# Access Compliance Report

## Public Rights-of-Way

### (Curb Ramps)

Intersection ID: 8925	Main Street: E_W_T_HARRIS_BV	Cross Street: THE_PLAZA	Location: NW
ADA ID: 4A1F4FE7F21E	Ramp Type: Perp	Initial Pass/Fail: Pass	Overall Compliance: No
Severity Score: 7.5			
Codes/Mitigation Info/Possible Solution		Field Measurements/Component Compliance

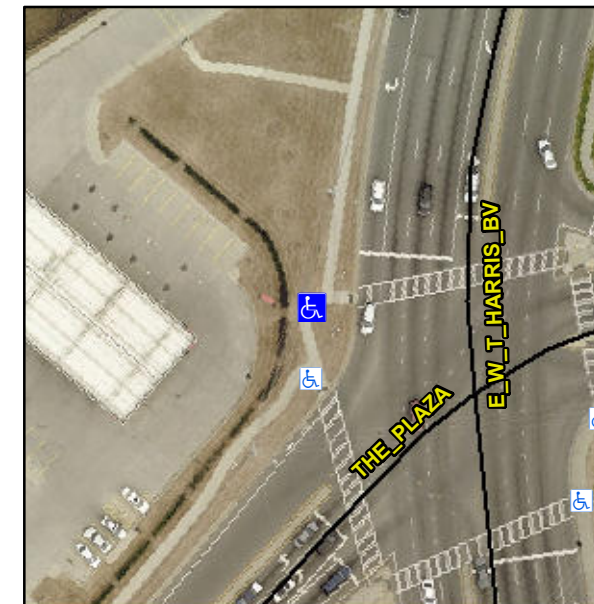
**Not Found, R304.2.2-Perp, R304.3.2-Para, R304.2.3, R305.1.4, R302.7**

Compliance	Description	Data	Compliance	Description	Data
N/A	Ramp Length (in)	131.0	Yes	Ramp Slope (%)	8.0
Yes	Ramp Width (in)	68.0	Yes	Ramp XSlope (%)	1.0
Yes	Flare Type LT	Curbed_NoWalkSurface	No	Flare Type RT	N/A
Yes	Flare Slope LT (%)	N/A	N/A	Flare Slope RT (%)	N/A
N/A	Flare Traversable LT?	No	N/A	Flare Traversable RT?	No
Yes	Landing Length (in)	72.0	Yes	DWS Provided?	Yes
Yes	Landing Width (in)	68.0	Yes	DWS Contrast?	Yes
No	Landing Slope (%)	2.1	Yes	DWS Length (in)	24.0
Yes	Landing X Slope (%)	2.0	No	DWS Full Width?	No
N/A	Landing Curb? (Y/N)	No	Yes	DWS Offset (in)	0.0
N/A	Shared Landing?	No			
No	Gutter Ponding?	Yes	Yes	Gutter Slope (%)	4.7
Yes	Gutter Lip Ht (in)	0.0	Yes	Gutter X Slope (%)	0.3
N/A	Painted X Walk1?	Yes	N/A	Painted X Walk2?	N/A
	X Walk 1 Direction	To E		X Walk 2 Direction	N/A
N/A	X Walk 1 Width (in)	114.0	N/A	X Walk 2 Width (in)	N/A
	X Walk 1 Slope (%)	4.5		X Walk 2 Slope (%)	N/A
	X Walk 1 X Slope (%)	1.2		X Walk 2 X Slope (%)	N/A

**Remove & Replace Entire Ramp.**
